DESIGN P	4	DRAWN BY	DART AEROSPACE HAWKESBURY, ONTARIO, CANAD	
Γ	CHECKED) Al	APPROVED A	DRAWING NO.	REV. A
ı		#	#	DSI 9366	SHEET 1 OF 2
r	DATE			TITLE	SCALE
	07.02	.07		CROSSTUBE SUPPORT CHANGE	NTS
	Α		07.02.07	NEW ISSUE

DART SERVICE INSTRUCTION

TO AMEND INSTALLATION INSTRUCTIONS IIN-D206-667 Rev. C AND INSTRUCTIONS FOR CONTINUED AIRWORTHINESS ICA-D206-667 Rev. 2

REF. CANADIAN STC: SH01-5 REF. FAA STC: SR01304NY

<u>FIGURE 1 — CROSSTUBE SUPPORT</u> INSTALLATION ON D407—667—205

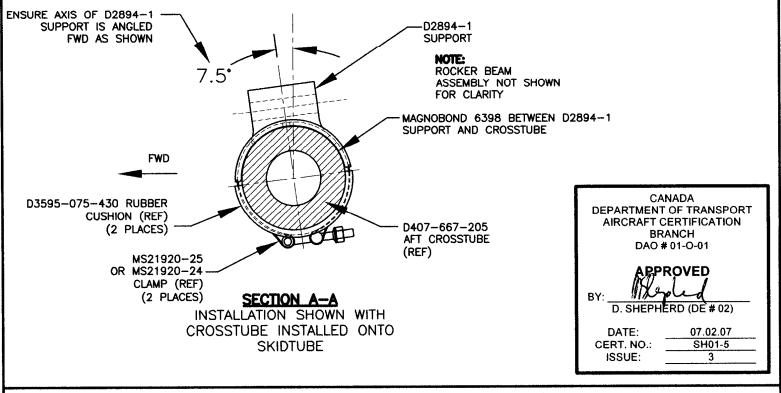
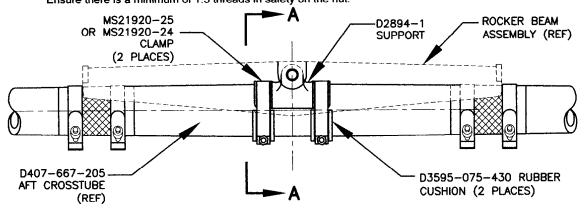
For D407-667-205 Aft Crosstubes at CHG 004 or later, the D2856-600-851 Abrasion Strip has been removed, the center D2894-1 Support has been bonded onto the crosstubes using Magnobond 6398 and D3595-075-430 Rubber Cushions have been installed underneath the MS21920-24/-25 Clamps. Amend Parts List of IIN-D206-667 Section 5 and ICA-D206-667 Section 32.8 as follows:

To prevent the center support from shifting on D407-667-205 Crosstubes at CHG 003 or earlier, the D2894-1 Support should be removed and re-installed as follows:

- 6) Apply a 0.03" to 0.06" thick layer of Magnobond 6398 underneath D2894-1 Support and re-install the Support on the crosstube as shown in Figure 1. Use rocker beam assembly to properly align the D2894-1 Support. Ensure the Rocker Beam Assembly can move freely without any friction with other parts. Position and secure the D2894-1 Support on the crosstube using MS21920-24/-25 Clamps. Install a D3595-075-430 Rubber Cushion underneath each MS21920-24/-25 Clamp. Torque clamps 80-100 in-lb. Let the D407-667-205 Crosstube Assembly cure before reinstalling the crosstube on the aircraft.

Note: The MS21920-24/-25 clamps are interchangeable to accommodate varying diameters. Ensure there is a minimum of 1.5 threads in safety on the nuts.

Note: The MS21920-24/-25 clamps are interchangeable to accommodate varying diameters. Ensure there is a minimum of 1.5 threads in safety on the nut.
